<b>ITEM: 6.8</b>	<b>COMMITTEE OF ADJUSTMENT REPORT SUMMARY MINOR VARIANCE APPLICATION FILE NUMBER A093/23 11 WHITEAULDS RD, MAPLE</b>
------------------	--

**COMMITTEE OF ADJUSTMENT REPORT  
MINOR VARIANCE APPLICATION  
A093/23  
11 WHITEFAULDS RD, MAPLE**

<b>ITEM NUMBER: 6.8</b>	<b>CITY WARD #: 1</b>
<b>APPLICANT:</b>	Mohammad Hossein Riahi Mahabadi, Soheila Ameri-Mahabadian
<b>AGENT:</b>	Anjia Home Design Inc.
<b>PROPERTY:</b>	11 Whitefaulds Road, Maple
<b>ZONING DESIGNATION:</b>	See below.
<b>VAUGHAN OFFICIAL PLAN (2010) DESIGNATION:</b>	Vaughan Official Plan 2010 ('VOP 2010'): "Low-Rise Residential"
<b>RELATED DEVELOPMENT APPLICATIONS:</b>	None
<b>PURPOSE OF APPLICATION:</b>	Relief from the Zoning By-law is being requested to permit a proposed secondary suite.

A0.1

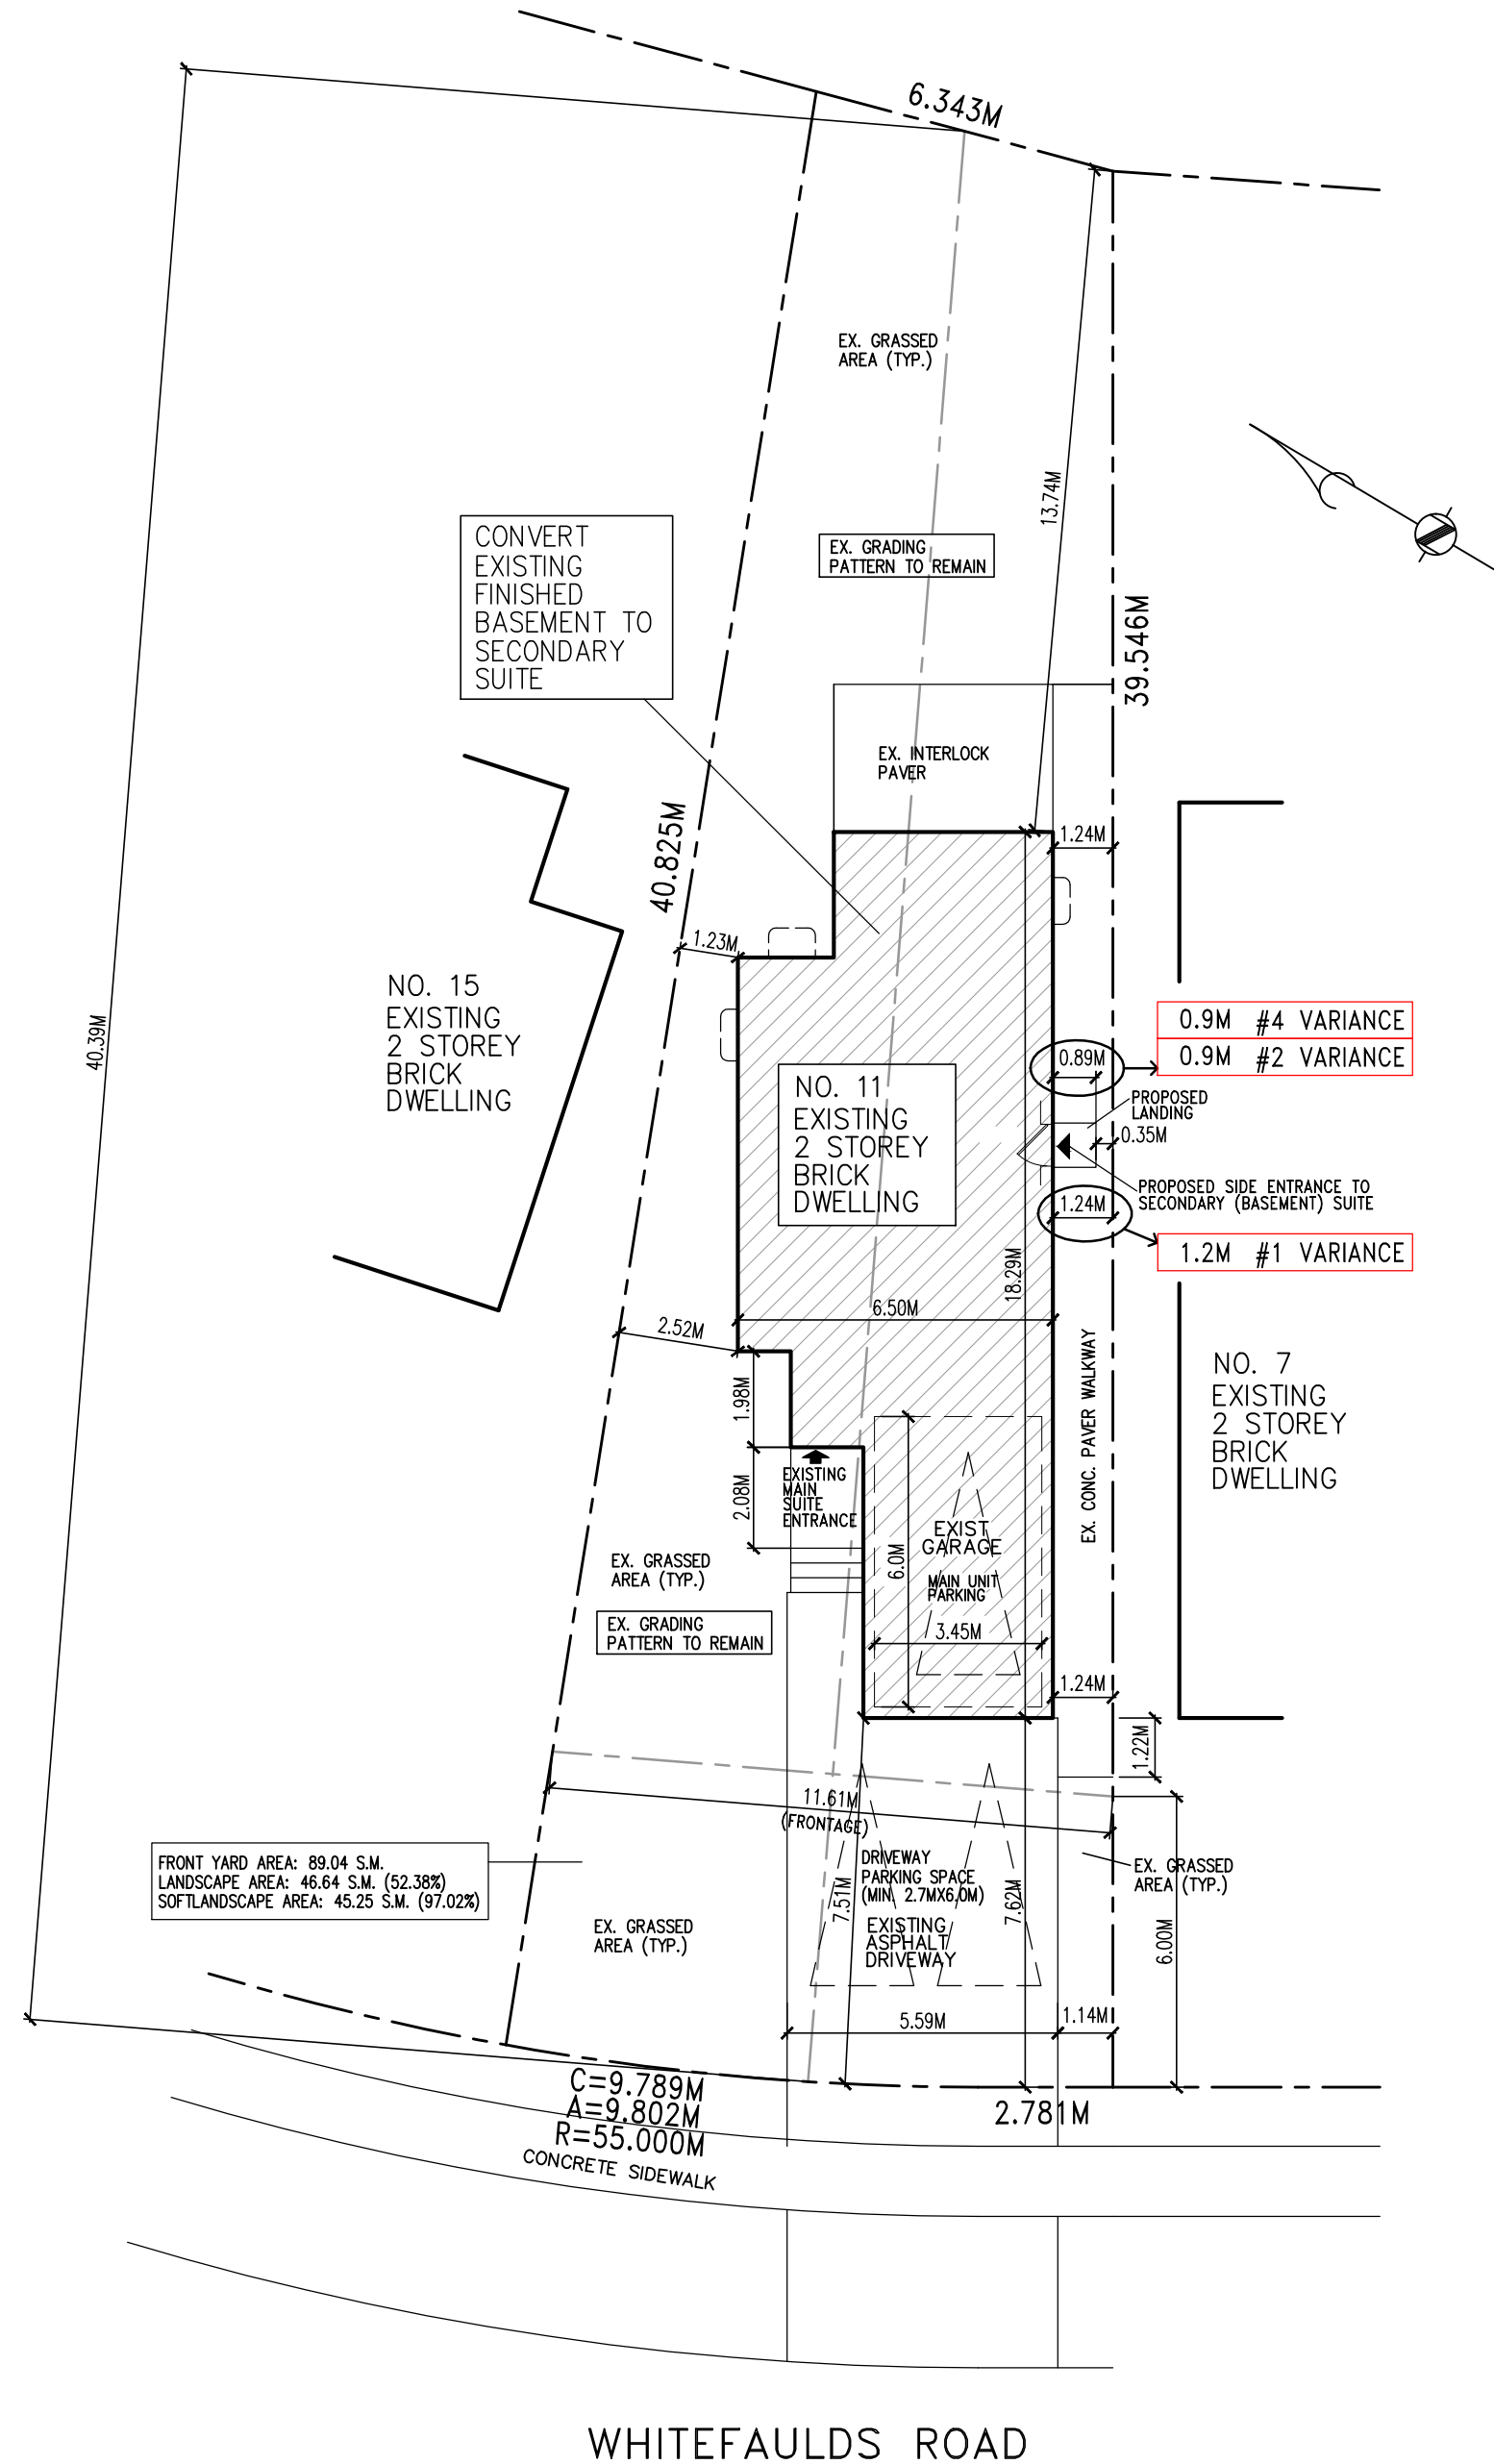
The Development Planning Department has no objection to Variance 1 for the interior side door access to the proposed secondary suite as it is an inward opening door that will not impede access through the side yard or encroach onto the neighbouring property when opened.

The Development Planning Department has no objection to Variances 2 and 4. The proposed entrance to the secondary suite is on the south wall of the dwelling. The south wall is perpendicular to the front lot line, so the Secondary Suite door would not face the street. The entrance to the Secondary Suite will not have a significant impact to the existing streetscape. When viewed from the street, the front porch and door leading to the main dwelling unit will continue to be the visually prominent entrance.

The Development Planning Department has no objection to Variance 3 as By-law 001-2021 excludes basements from the total gross floor area ('GFA') calculation. The By-law's definition of GFA excludes basements. Therefore, only the main and second levels of the dwelling, comprising an area of 141.7 m<sup>2</sup>, are used in the GFA calculation. With the basement included, the total habitable space within the single detached dwelling rises to 210.9 m<sup>2</sup>, and the Secondary Suite would occupy approximately 32.81% of the dwelling's total habitable space. Development Planning recognizes that the variance is triggered due to the way in which the By-law requires the GFA to be calculated. If the GFA included the basement level, the Secondary Suite would comply with the area requirements. The Secondary Suite will remain accessory in relation to the primary dwelling unit due to its size and location relative to the primary dwelling unit.
